Southern Nuclear
Operating Company, Inc.
42 Inverness Center Parkway
Birmingham, Alabama 35242

February 24, 2017

ND-17-0295
10 CFR 50.90
10 CFR 52.63

Southern Nuclear Operating Company
Vogtle Electric Generating Plant Units 3 and 4
Request for License Amendment and Exemption:
Standardization of Instrumentation Setpoint Nomenclature (LAR-17-004)

**Table 6.2.3-1 (Sheet 4 of 4)  
 Containment Mechanical Penetrations and Isolation Valves**

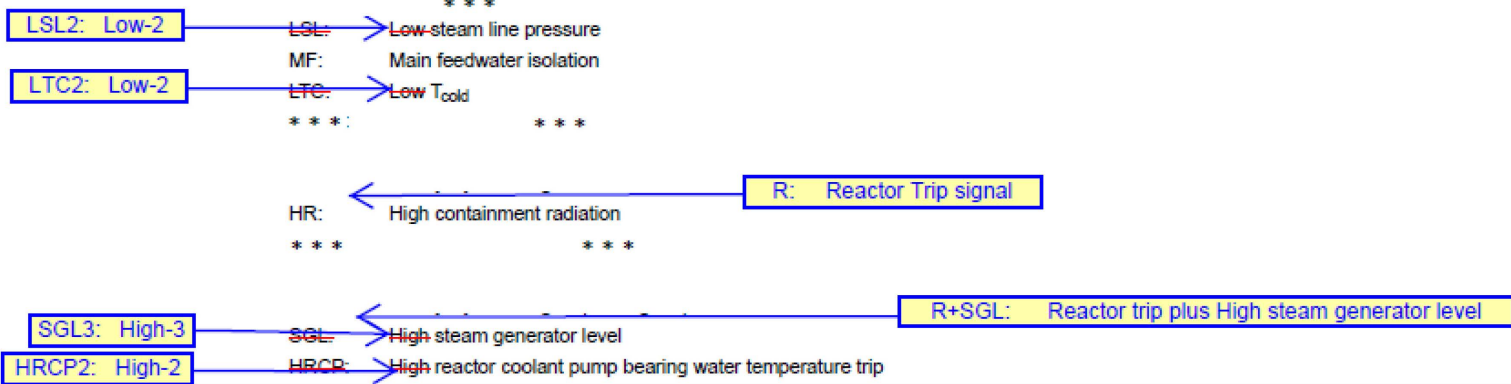
| PMS Parameter | COL Appendix C (and corresponding Tier 1 information) | COL Appendix A (TS) | Tier 2 Locations |
|--|---|----------------------------|---|
| Steam Line Pressure: "Low" changed to "Low-2" | N/A | Table 3.3.8-1, Function 24 | <u>Chapter 3</u> Section 3.9.1.1.4.3 <u>Chapter 6</u> Section 6.2.3.3 Table 6.2.3-1 Section 6.3.3 <u>Chapter 7</u> Figure 7.2-1 (sheet 9, 11) Section 7.3.1.1 Section 7.3.1.2.10 Section 7.3.1.2.24 Section 7.3.1.5.5 Table 7.3-1 Table 7.3-2 <u>Chapter 10</u> Section 10.3.2.2.3 Section 10.3.2.2.4 Table 10.3.3-1 <u>Chapter 14</u> Table 14.3-2 ... |

Figure 7.2-1 (Sheet 2 of 21)

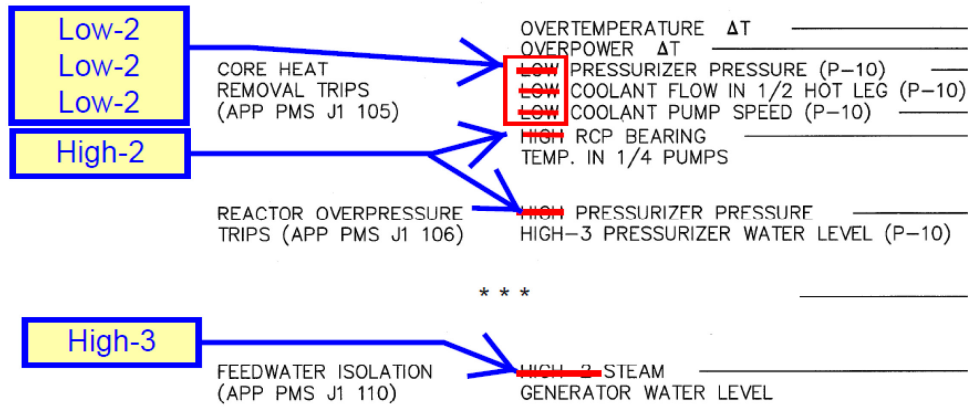
| PMS Parameter | COL Appendix C (and corresponding Tier 1 information) | COL Appendix A (TS) | Tier 2 Locations |
|---|---|----------------------------|---|
| Pressurizer Pressure: "High" changed to "High-2" | Table 2.5.2-2 | Table 3.3.1-1, Function 5b | <u>Chapter 5</u> Section 5.4.5.2.3 <u>Chapter 7</u> Section 7.2.1.1.4 Section 7.2.2.2.2 Table 7.2-2 Figure 7.2-1 (sheets 2,6) Section 7.7.1.6 WCAP-16675, Section 1.1 <u>Chapter 15</u> Table 15.0-4a Table 15.0-6 Section 15.2.2.1 Section 15.2.3.2.1 Section 15.2.3.2.2 Section 15.2.8.1 Section 15.2.8.2.1 Table 15.2-1 Section 15.4.2.1 Section 15.5.2.1 Section 15.5.2.2 Section 15.5.2.4 |

Figure 7.2-1 (Sheet 15 of 21)
* * *

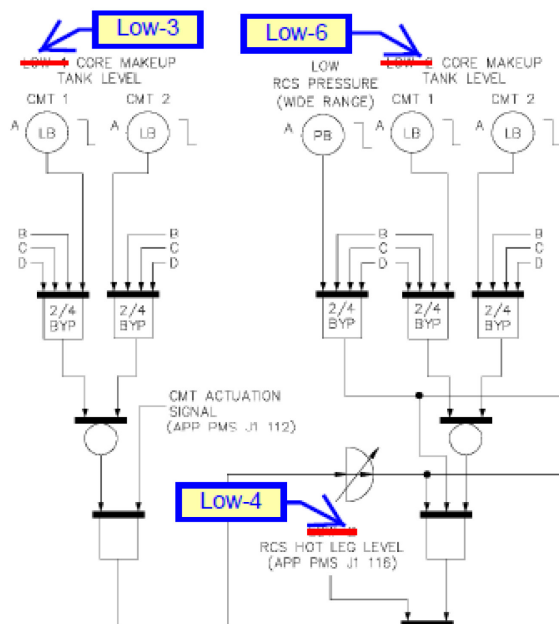
| PMS Parameter | COL Appendix C (and corresponding Tier 1 information) | COL Appendix A (TS) | Tier 2 Locations |
|--|---|---------------------------------------|--|
| CMT Water Level: a. "Low-1" (or "Low") changed to "Low-3" b. "Low-2" (or "Low-Low") changed to "Low-6" | N/A | Table 3.3.8-1, Functions 15 and 16 | <u>Chapter 1</u> Section 1.9.3 item (1)(vii) <u>Chapter 7</u> Figure 7.2-1 (sheet 15) Section 7.3.1.2.4 Table 7.3-1 <u>Chapter 14</u> Table 14.3-2 <u>Chapter 15</u> Table 15.0-4a Table 15.6.5-10 <u>Chapter 19</u> Section 19E.2.3.2.3 |

| PMS Parameter | COL Appendix C (and corresponding Tier 1 information) | COL Appendix A (TS) | Tier 2 Locations |
|---|---|--------------------------------------|---|
| RCS Hot Leg Water Level: a. "Low-1" (or "Low") changed to "Low-2" b. "Low-2" (or "Low" or "Low-Low") changed to "Low-4" | N/A | Table 3.3.10-1, Functions 1 and 2 | <u>Chapter 6</u> Section 6.3.3.4.3 <u>Chapter 7</u> Figure 7.2-1 (sheet 15,16) Section 7.3.1.2.2 Section 7.3.1.2.4 Section 7.3.1.2.22 Table 7.3-1 Table 7.3-2 WCAP-15775, Sections 5.4.1, 5.4.9 and 5.5.6 <u>Chapter 9</u> Section 9.3.6.7 <u>Chapter 19</u> Table 19.59-18 Section 19E.2.1.2.2 Section 19E.2.1.2.4 Section 19E.2.3.2.3 Section 19E.2.3.3.1 |

Table 7.3-1 (Sheet 1 of 9)

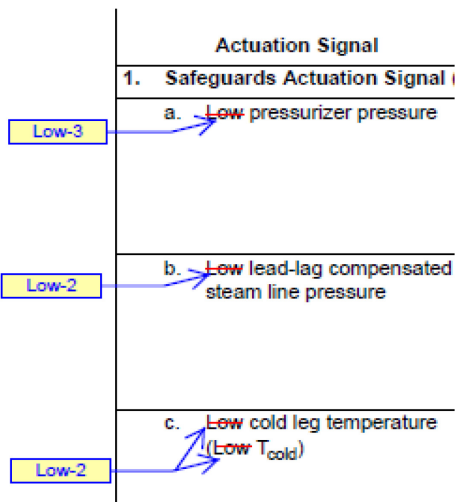
| PMS Parameter | COL Appendix C (and corresponding Tier 1 information) | COL Appendix A (TS) | Tier 2 Locations |
|---|---|---------------------|--|
| <p>UFSAR change only: “Low” and “Low-1” setpoint designators changed to “Low¹⁰”; and “High” and “High-1” setpoint designators changed to “High¹⁰” Footnote 10 added stating: “Low and Low-1 are considered to be equivalent terms when referring to the first low setpoint designator. High and High-1 are considered to be equivalent terms when referring to the first high setpoint designator.”</p> | <p>N/A</p> | <p>N/A</p> | <p><u>Chapter 7</u> Table 7.3-1</p> |
